## **PLAN REVIEW SHEET**

2015-006

Sam's Investments IV, LLC

**Waiting Pad Detail**

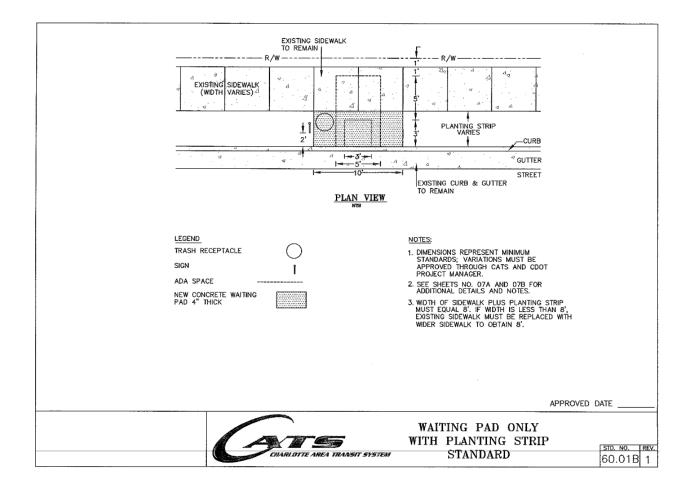
The Petitioner is requested to provide and construct a concrete pad for a relocated bus stop on Northlake Centre Parkway. Below is an image of the standard detail (60.01B) for the requested concrete pad. The site plan may either show the conceptual location of the improved bus stop on Northlake Centre Parkway, or alternatively, include a development note to locate the bus stop pad during the development review and permitting process.
